1 INTRODUCTION

- 1.1.1 Prime Transport Planning Ltd (Prime) have been provided with comments from Phil Palmer (Highway Development Control Engineer) at Wrexham County Borough Council (WCBC) dated 29th January 2019. These comments were made in relation to the Transport Assessment (TA) prepared in support of an outline planning application (EP/DC/P/2018/1087) for proposed commercial development located off Clywedog Road South on Wrexham Industrial Estate (WIE). The development is split over two parcels of land, each parcel having their own separate access point onto Clywedog Road South. The northern parcel of land comprises B2/B8 usage, of up to 70,000 sqft. The southern parcel of land comprising up to 27,073 sqft, of B1/B2 usage.

WREXHAM INDUSTRIAL ESTATE - SITE 5

P18045-001C

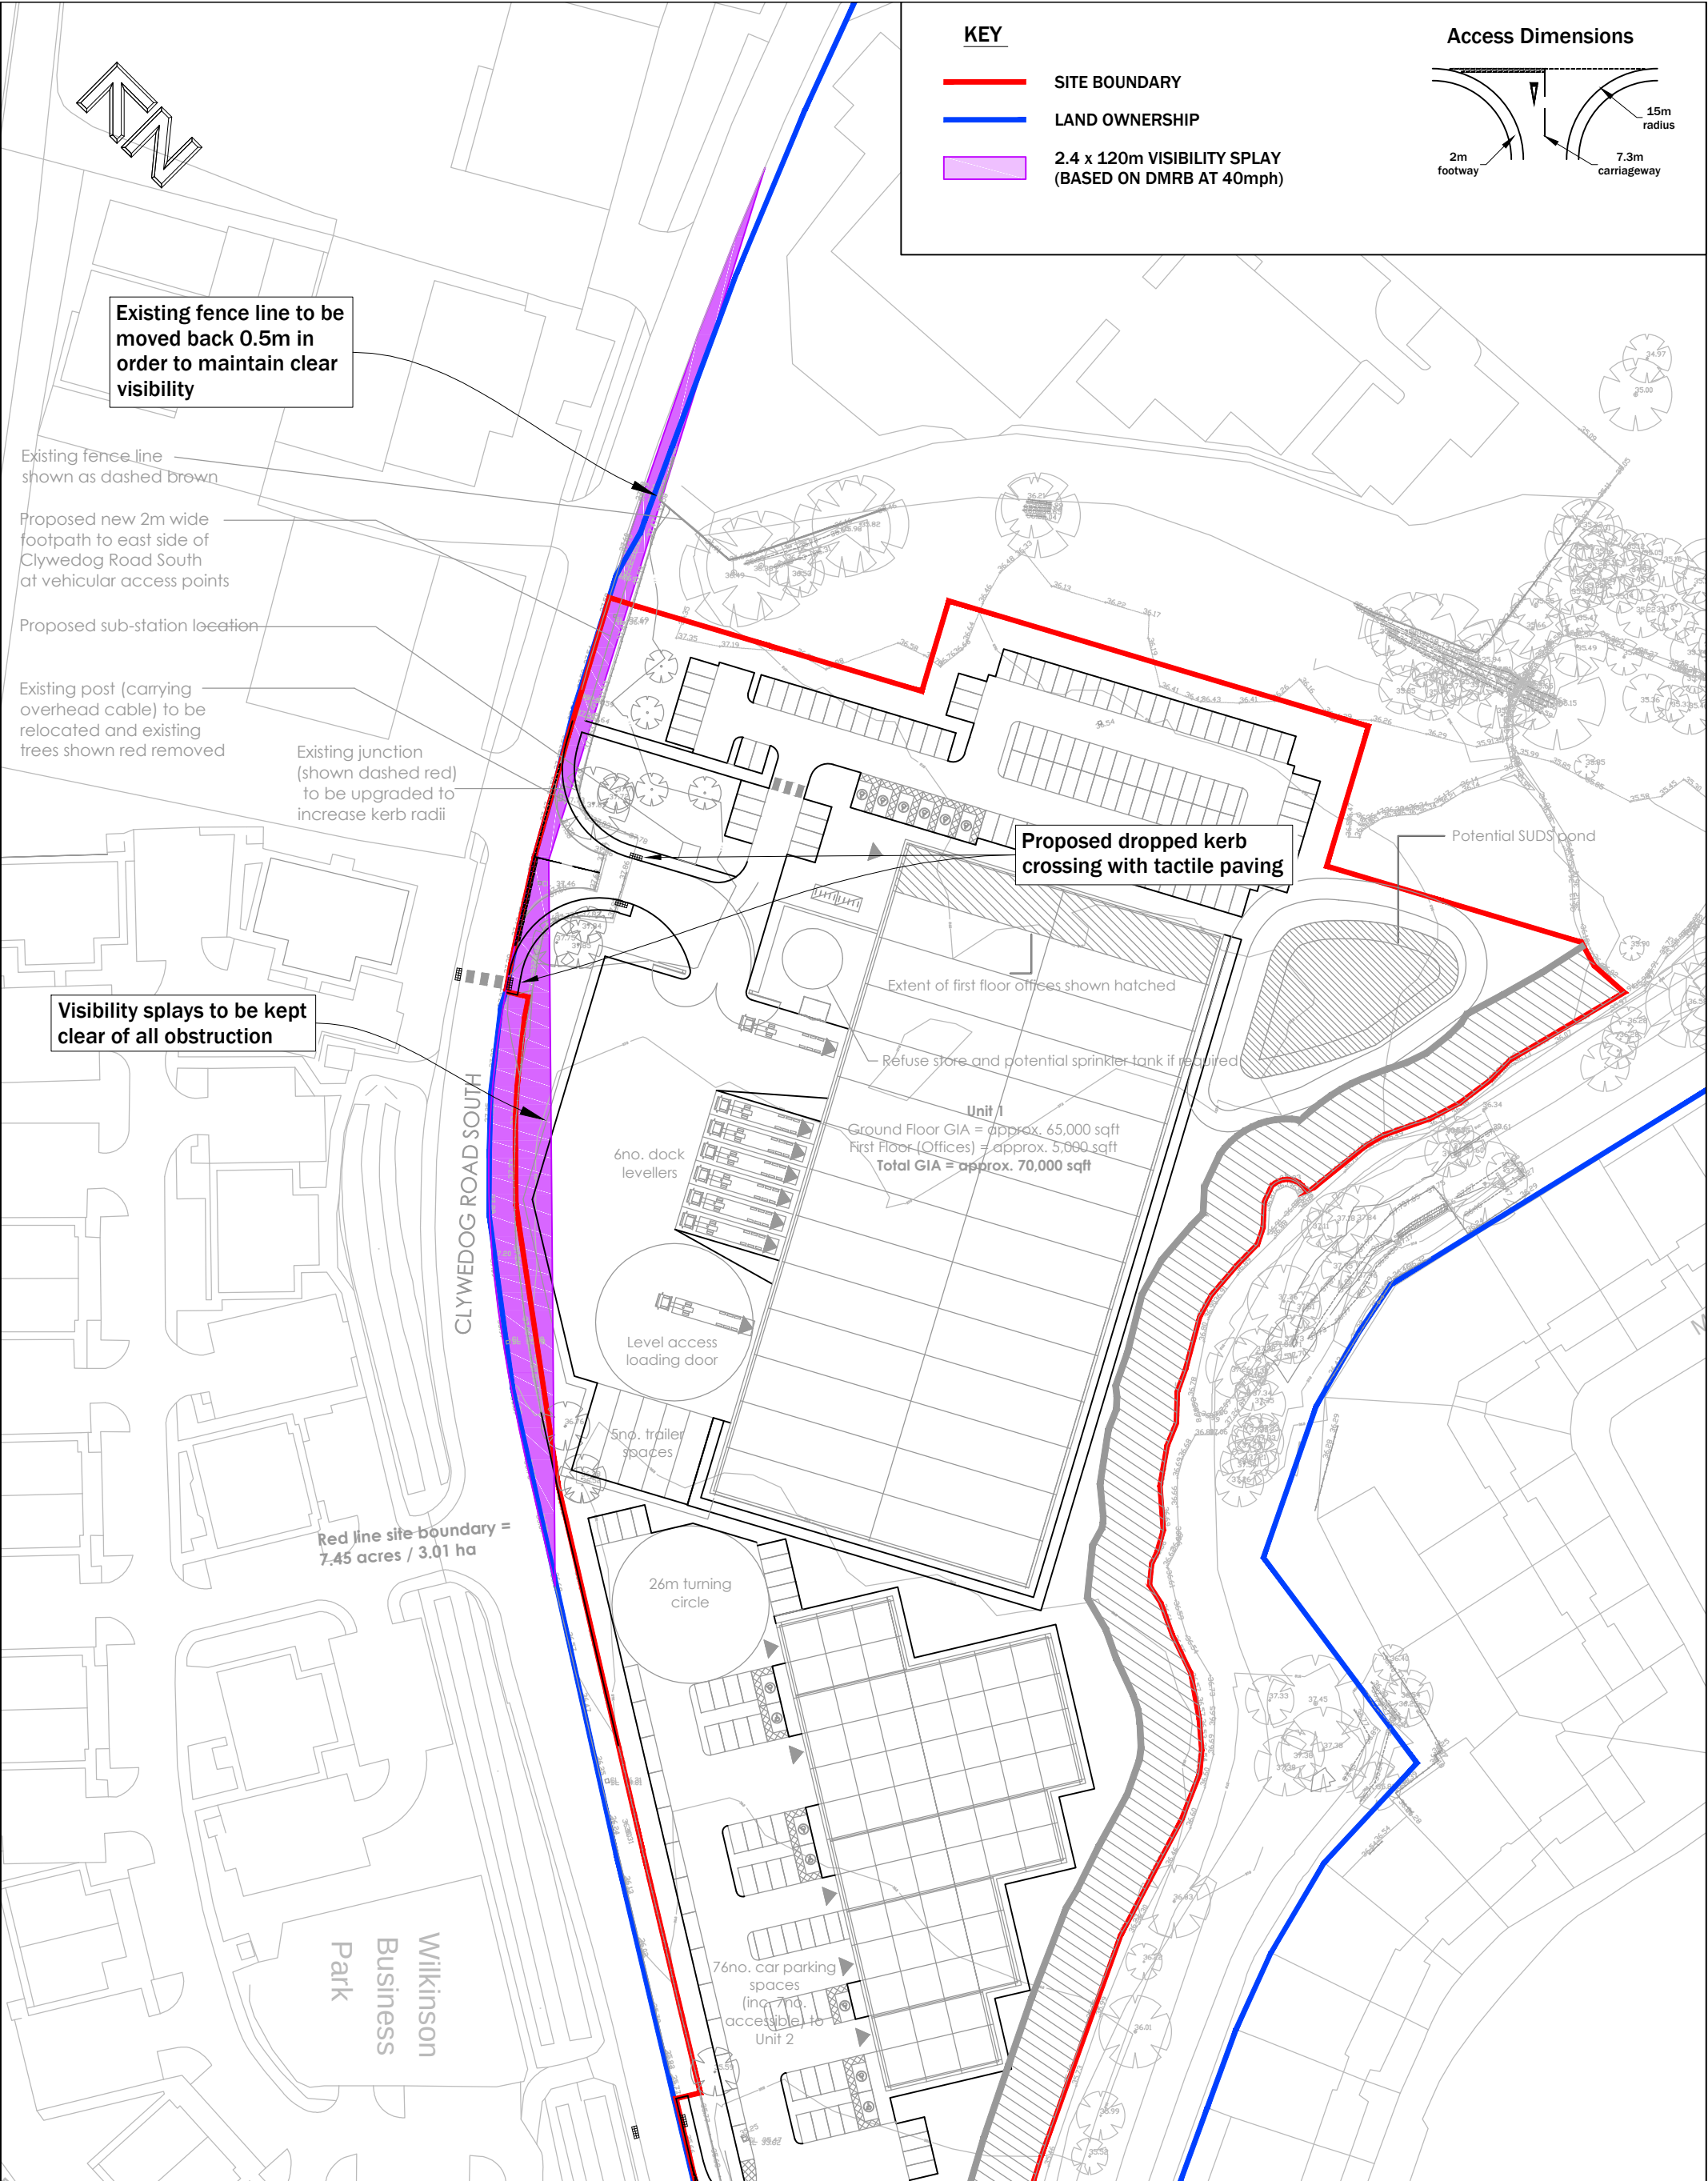
- 2.1.1 *Point 1: There would appear to be an existing boundary fence fronting the adjoining site (ie/ Nu Instruments) which may impede visibility from the proposed northerly access. I would recommend that the existing fence is plotted on a revised visibility layout plan*

- 2.1.3 *Point 2 - The proposed access appears to be located directly opposite an existing access serving RF Bellis Haulage which is considered unacceptable. I would recommend that a revised plan is submitted indicating a more appropriate access location*

- 2.1.8 *Point 3 - I would recommend that a 2m wide footway is provided on both sides of the access extending into the site. A suitable dropped kerb crossing point including tactile paving will be required across the access at the narrowest point of the access. This can represent the limit of adopted highway. I would recommend that a revised plan is submitted indicating this detail*

- 2.1.10 *Point 4- The submitted plan does not appear to indicate any footway provision (2m wide) extending along the entire site frontage. If the proposed development is to be supported, I would recommend that a 2m wide footway is constructed along the entire site frontage which extends north to provide a continuous footway link with the existing footway fronting Nu Instruments*

- 2.1.2 Amended access drawing **P18045-001C**, provided within **Appendix I** of this report, notes the above-mentioned fence. This fence is to be moved back 0.5m in order to maintain a clear visibility at 2.4m x 120m visibility splays (considered acceptable by the highways officer).

- 2.1.4 The access point for the northern parcel of Site 5 is pre-existing and therefore we would suggest is an appropriate location to utilise for access to this particular development parcel. The WCBC suggested criteria for the spacing of opposite and adjacent junctions typically relate to junctions on main roads and not private access points. The purpose of the spacing criteria is to avoid the provision of cross

- 2.1.5 Given the above we suggest that the location of the proposed access remains in the location shown on drawing **P18045-001C**. It can be seen from this drawing that the current site access location allows for the agreed visibility splays of 2.4m x 120m (DMRB@40mph) to be achieved from the proposed site access with similar levels of visibility being achievable from the existing access to RF Bellis Haulage Ltd. The geometry of Clywedog Road South also means that SSD on the main road approach to this junction is well in excess of the DMRB requirements for the prevailing 40mph speed limit.

- 2.1.9 It should be noted that 2m wide footways either side of the access road were already proposed with the original submission for Site 5 and access drawing **P18045-001B**. Access drawing **P18045-001C**, provided within **Appendix I** of this report further continues to show this provision of footway, and newly provided dropped kerb crossing.

- 2.1.14 Given the above, we would suggest that the provision of a footway along the eastern side of Clywedog Road South is unnecessary. The suggested provision for pedestrians for this particular parcel of land is shown on drawing **P18045-001C**, provided within **Appendix I** of this report

P18045-002C

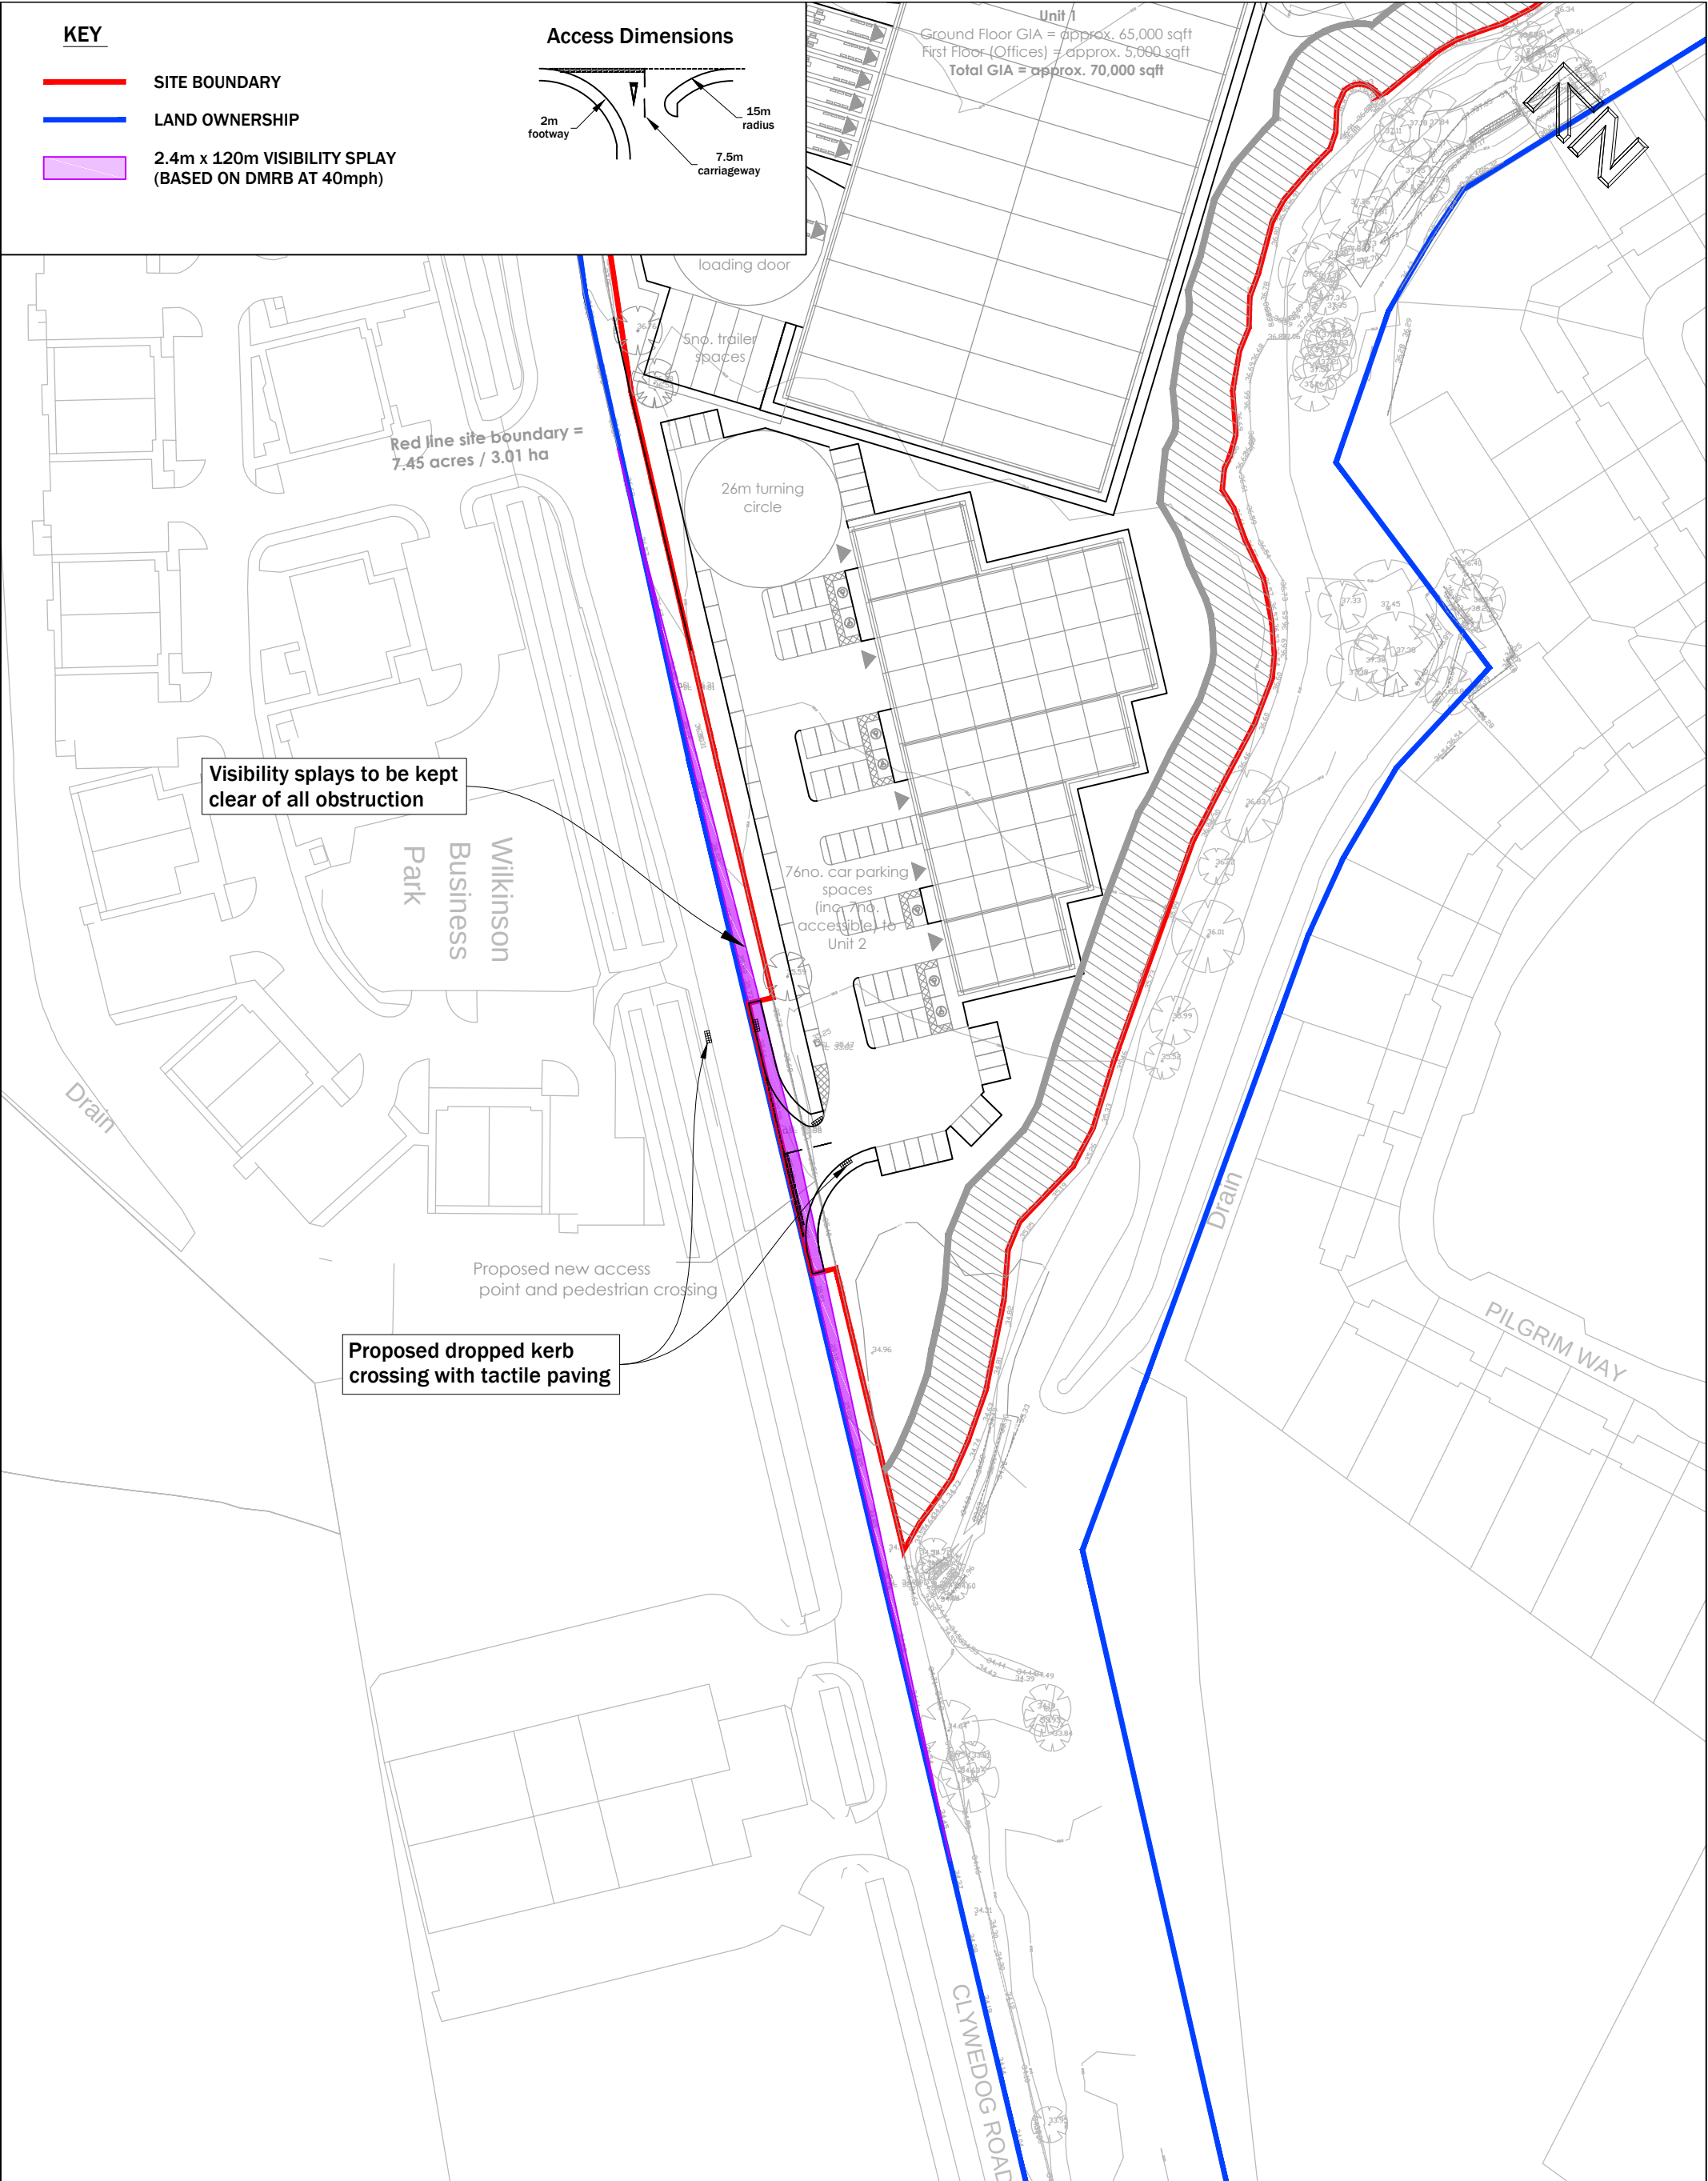
- 2.2.1 *Point 5 - The proposed access appears to be 14 wide with limited kerb radii. There would appear to be a turning facility located directly behind the access to allow 16.5m HGVs to turn. This arrangement is considered unacceptable and has the potential for conflict of vehicle movements entering/exiting the site. I would recommend that the applicant considers re-locating the access further to the north east where the site has potentially more depth to accommodate a more suitable access*

- 2.2.5 See paragraph 2.1.10 – 2.1.14 above.
- 2.2.6 *Point 7 – I would recommend that a 2m wide footway is provided on both sides of the access extending into the site. A suitable dropped kerb crossing point including tactile paving will be required across the access at the narrowest point of the access.*

- 2.2.2 Amended access drawing **P18045-002C**, provided within **Appendix I** of this response, details the reduced access carriageway width to the site. The access can be seen to be 7.5m in width with 15m radii. Drawing **P18045-004C** contained within **Appendix I** demonstrates that a 16.5m articulated lorry can still access and egress the site via this amended access point. The turning facility located directly behind the access has been removed in line with WCBC comments, vehicles turning within the site can still be accommodated within the turning circle shown toward the northern part of this site.

- 2.2.7 It should be noted that 2m wide footways were already proposed either side of the carriageway along with the original submission for Site 5 and drawing **P18045-002B**. Amended access drawing **P18045-002C** provided within **Appendix I** of this report further continues to show this provision of footway, and newly provided dropped kerb crossing.
